## WATERVIEW CONNECTION

#### Supplementary Section 42A Report Groundwater and Settlement

Report prepared for:  
**ENVIRONMENTAL PROTECTION AGENCY**  
(Ministry for the Environment)  
On behalf of:  
**WATERVIEW CONNECTION BOARD OF INQUIRY**

Report prepared by:  
**EARTHTECH CONSULTING LIMITED**  
P O Box 721, Pukekohe  
Phone: 64-9-238 3669

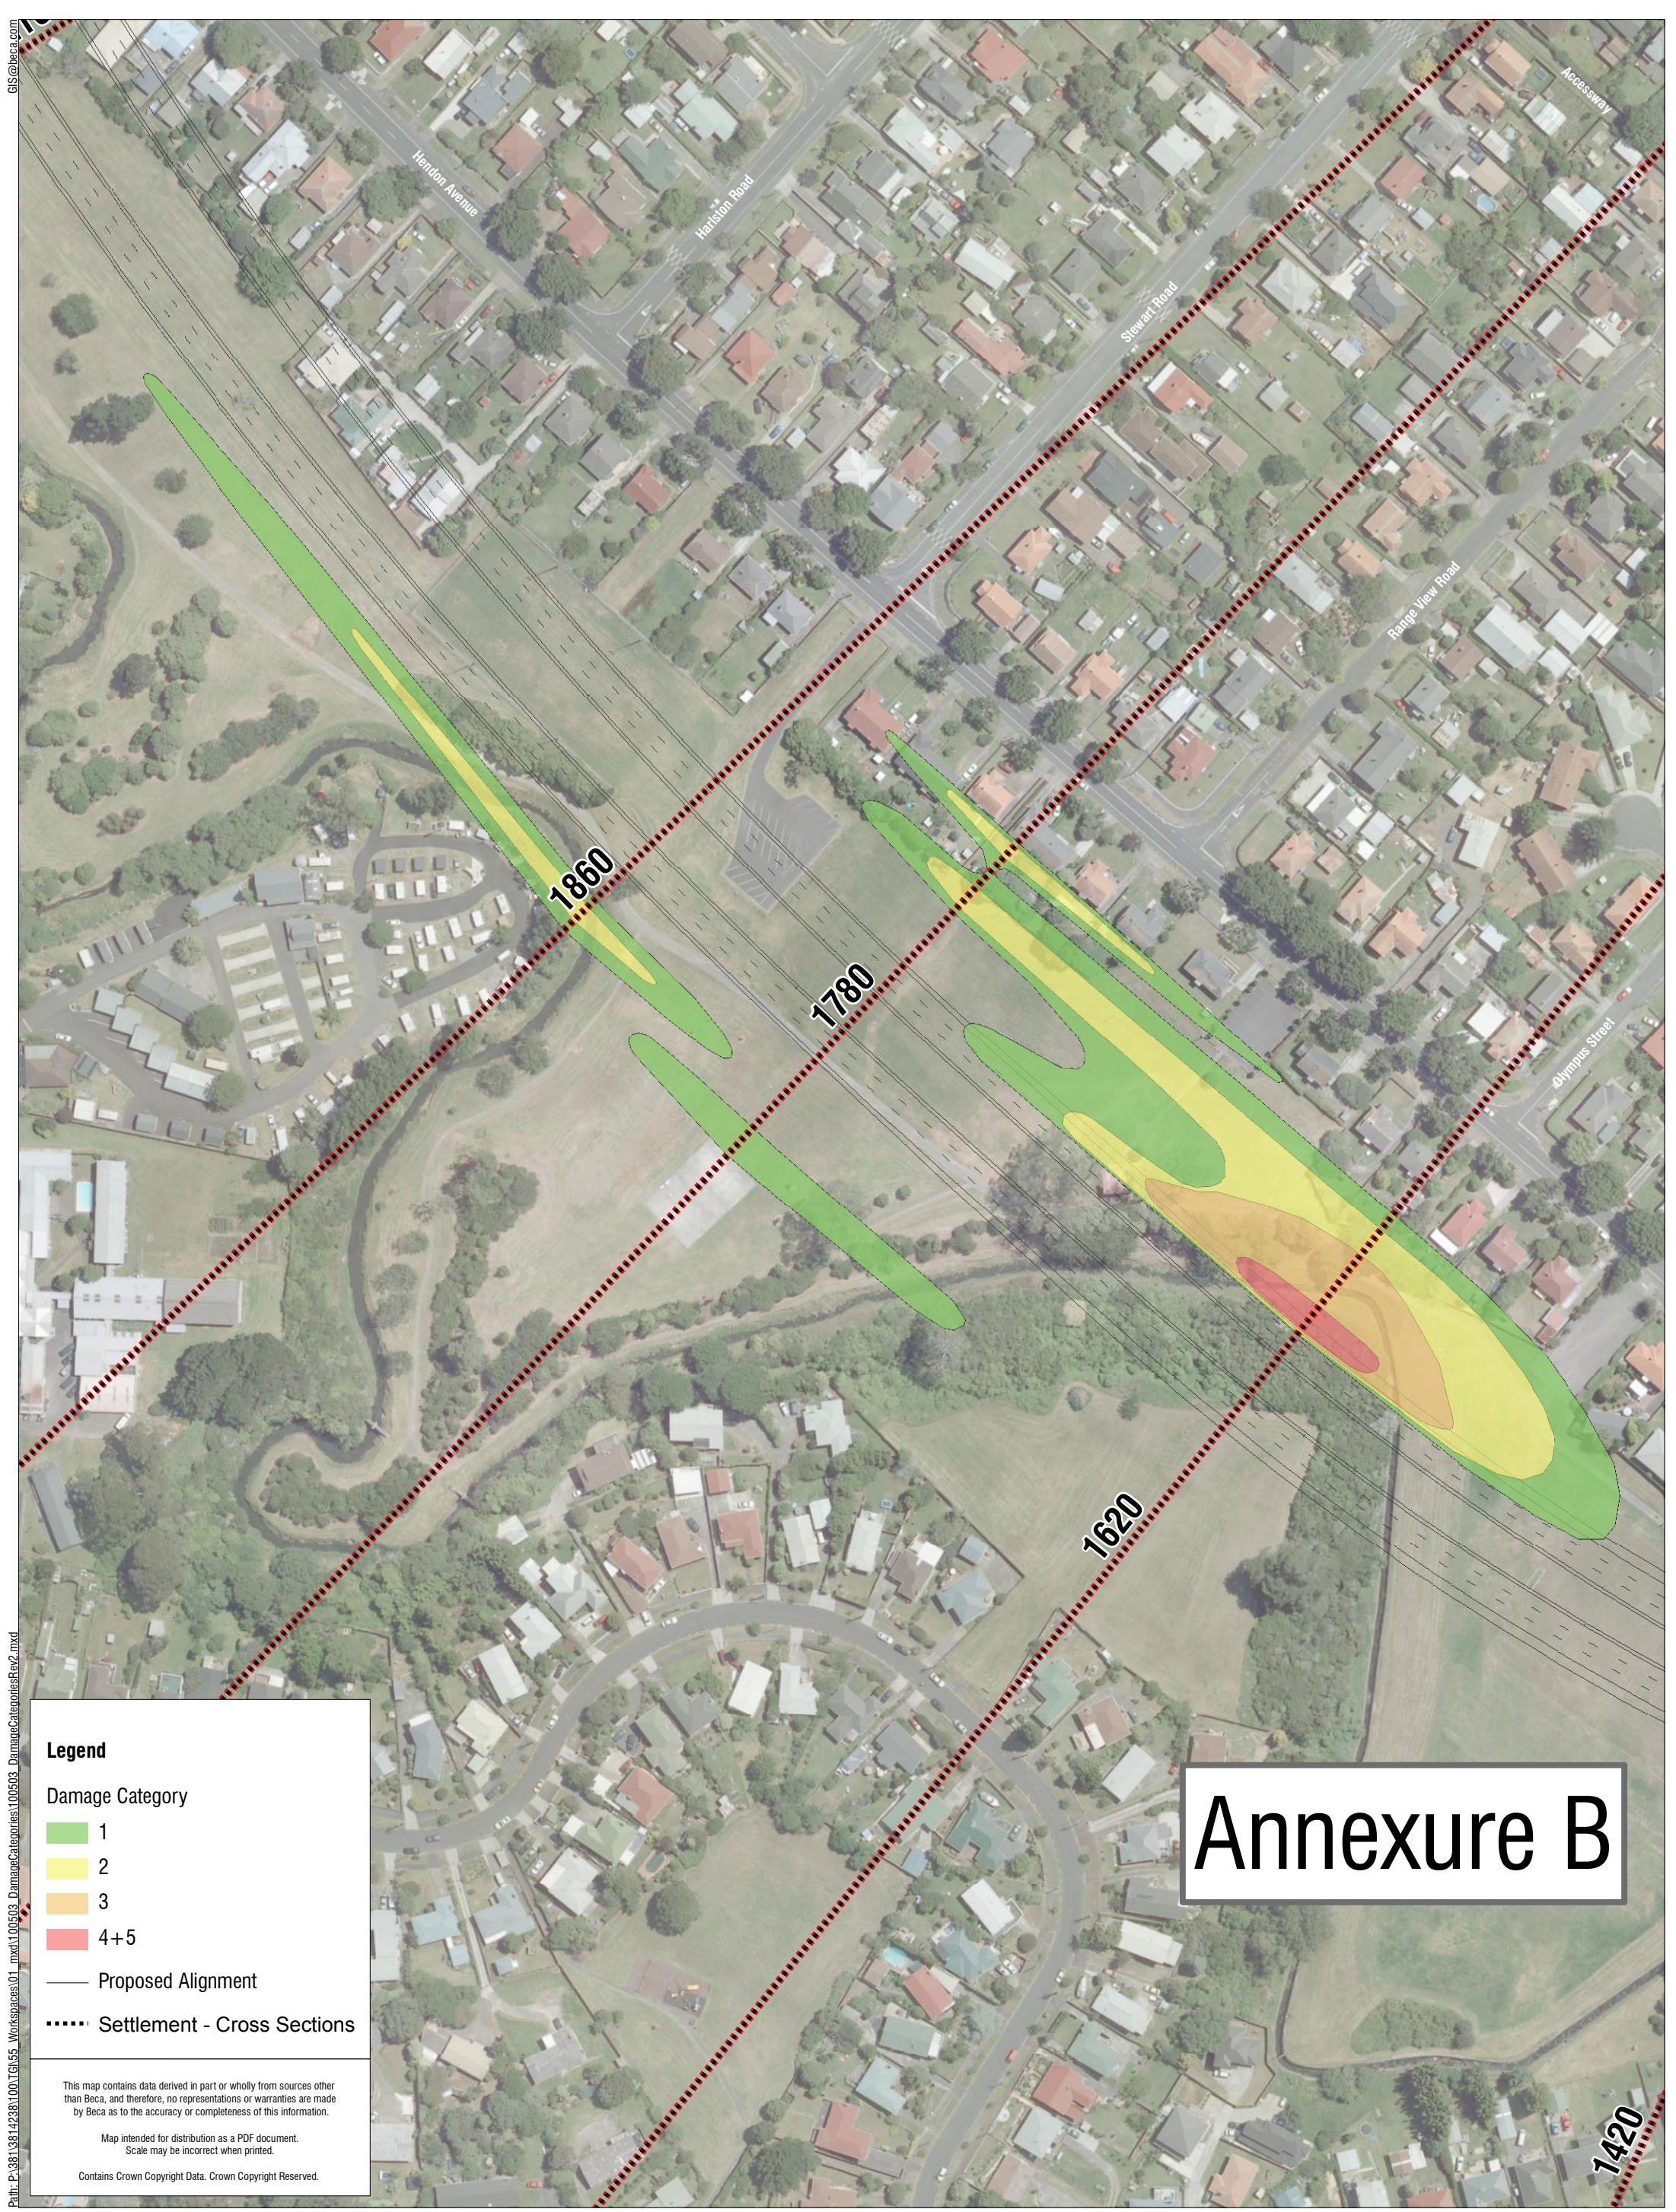
These building categories have in turn been overlaid on site plans to show where the tunnelling and/or excavation works could result in building damage. These plans are provided in Figures G1, G2 and G3 (attached in Appendix A). These provide the best assessment of areas where possible building damage may occur.

Mr Alexander's amended condition requires an updated version of the settlement prediction (Figure E14) and the building damage categories (Sheets G1, G2 and G3) prior to construction. The outcome of this update is not certain and may lead to an increase or decrease in the effects. This leaves affected parties and the Hearing Committee with no certainty that the effects will be no more than currently predicted. Adding the following paragraph to S.1 provides more certainty.

DRAWN	P.K	CHECKED	P.K	SCALE (A3)	SHEET
TRACED	C.M/M.W.	DATE	22 Dec 2010	1:5000(h) 1:2000(v)	<b>FIG. B3</b>
					VERSION <b>A</b>
					REF 3119

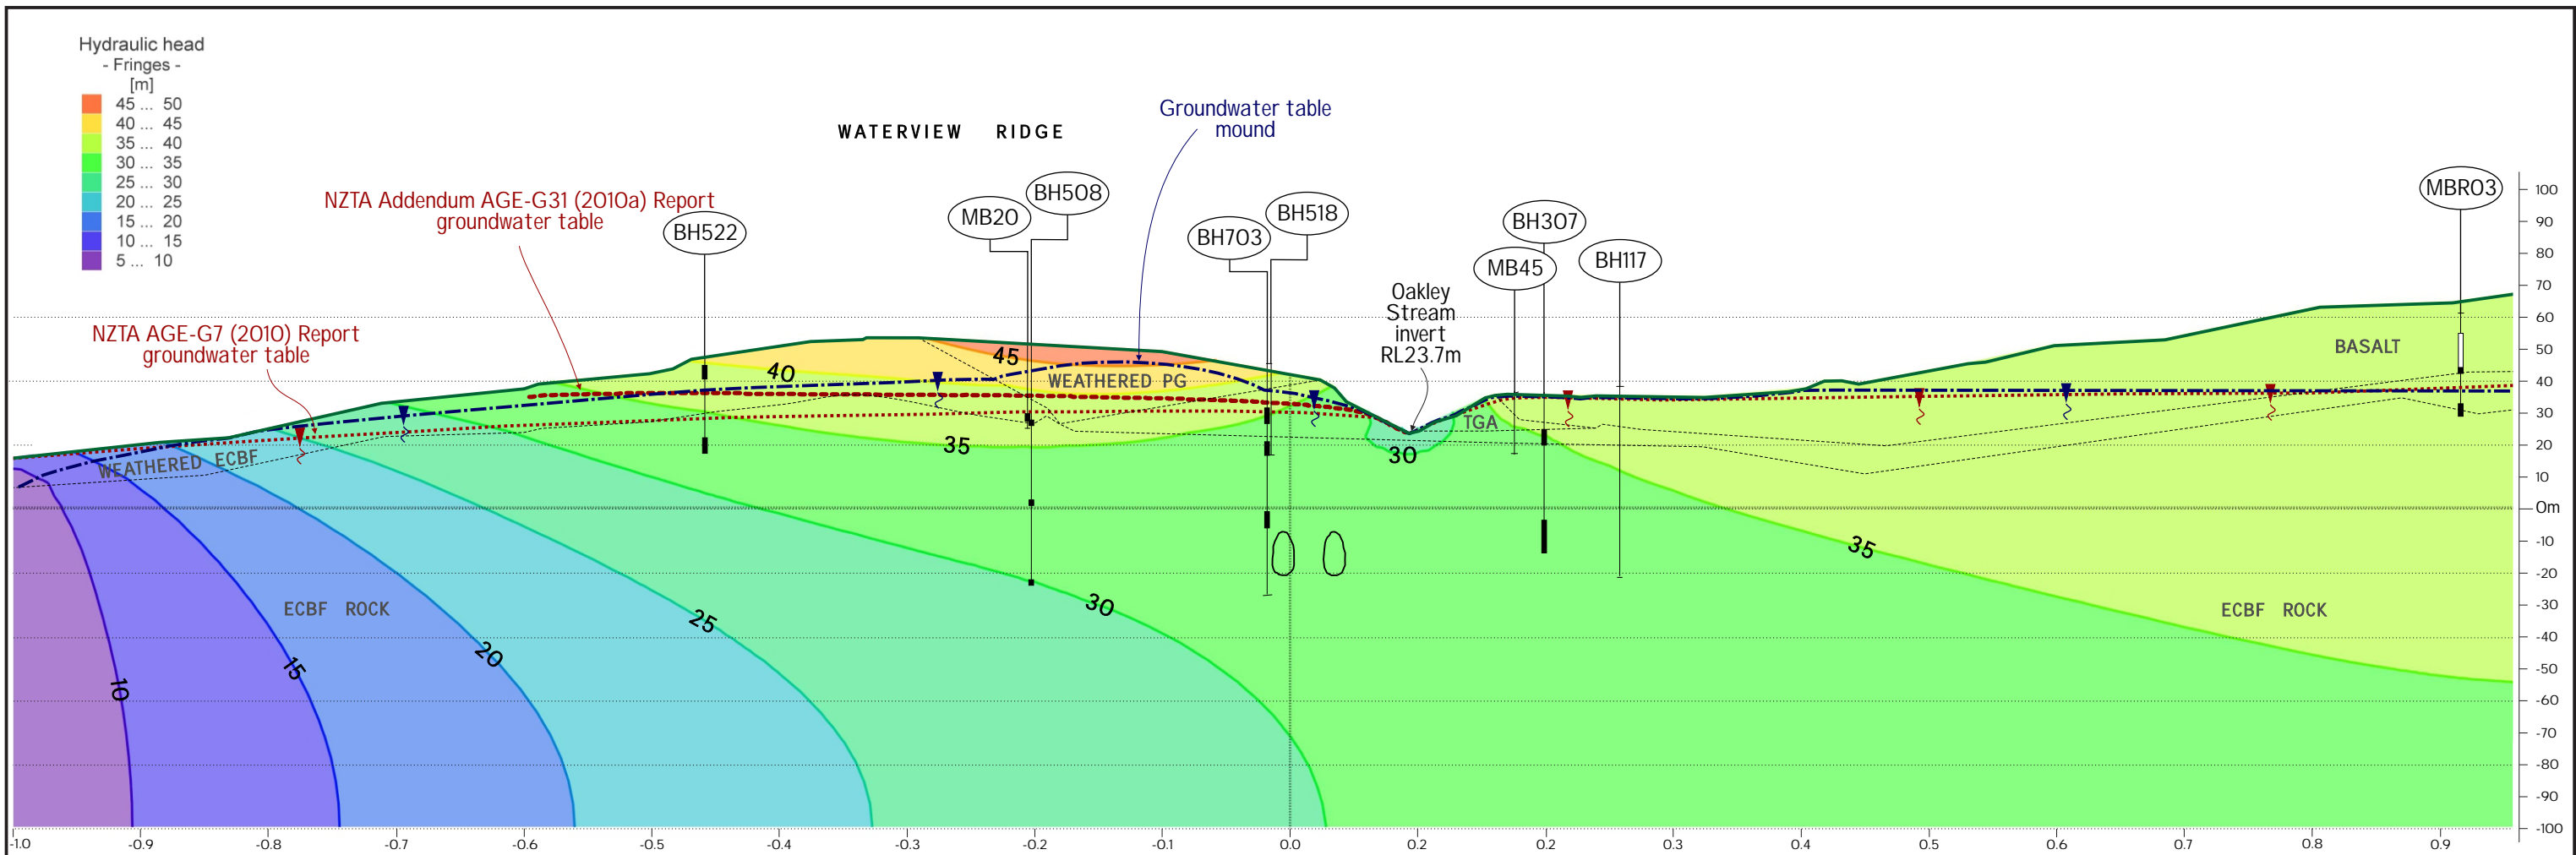
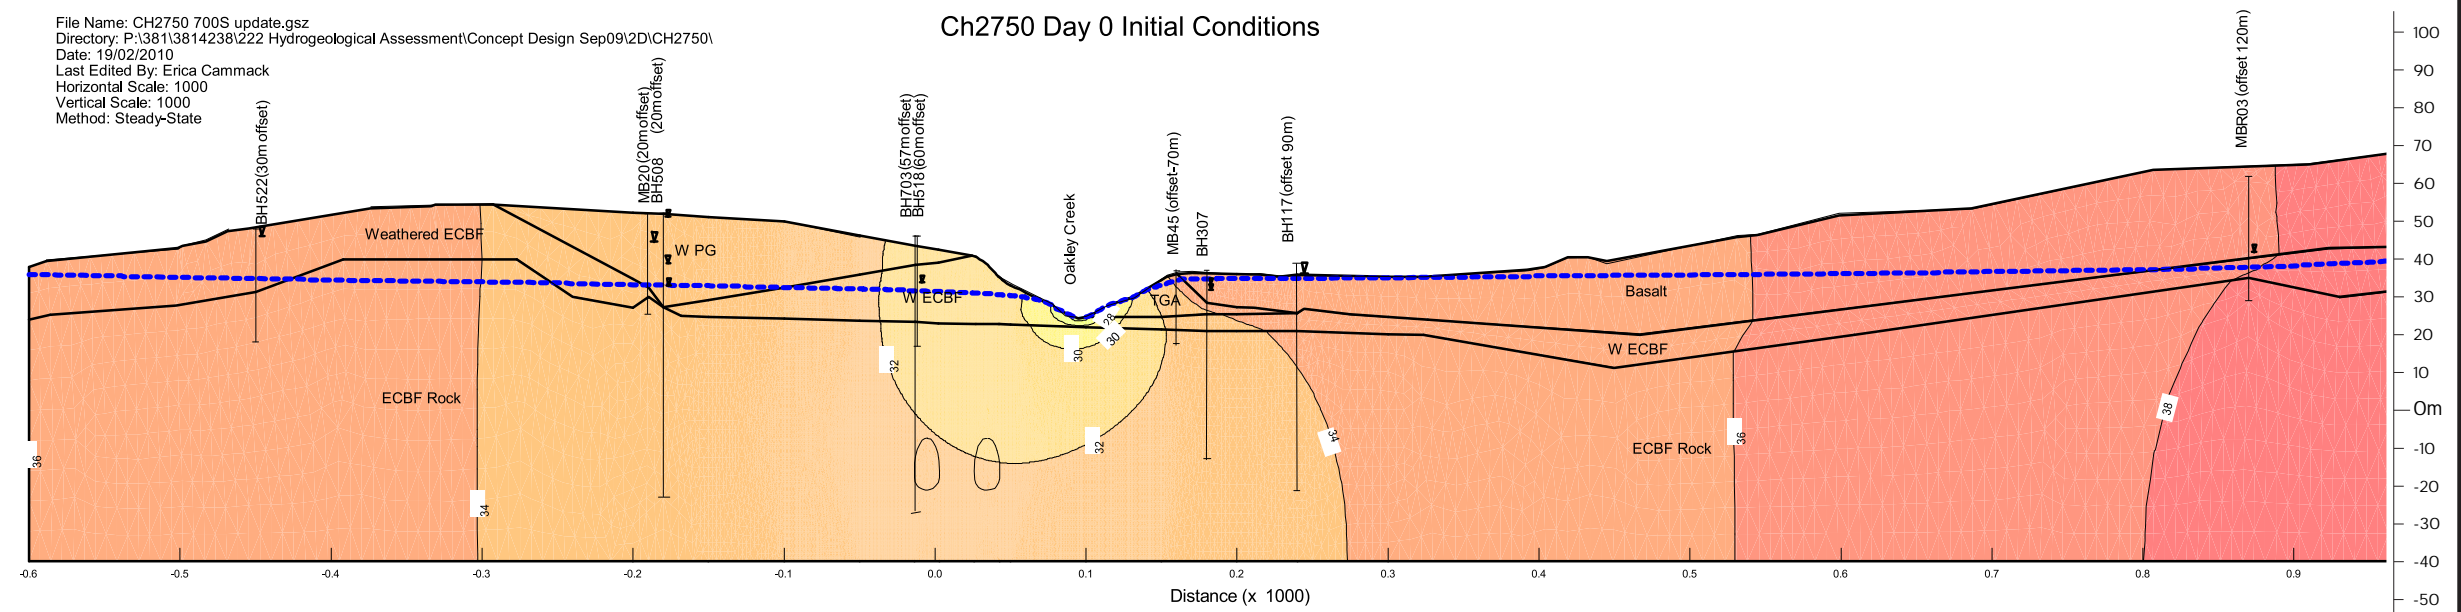
Figure B3 shows the Earthtech and NZTA calibrated models for Ch2750m. In terms of the central Waterview Ridge area, the differences are as follows:

<b>Ch2750m 2D Model</b>	<b>Groundwater Table Level</b>
i. NZTA (AGE)	RL32 to 34m
ii. Earthtech	RL42 to 45m

The 2D NZTA modelling only shows limited mounding of the groundwater table under Waterview Ridge and is not considered to be adequately calibrated.

The increased settlement predicted is demonstrated in the Addendum AGE where predicted total settlements increased by 26% for an initial groundwater table approximately 5m higher than that modelled at Ch2750m in the AGE (see Figure B3).
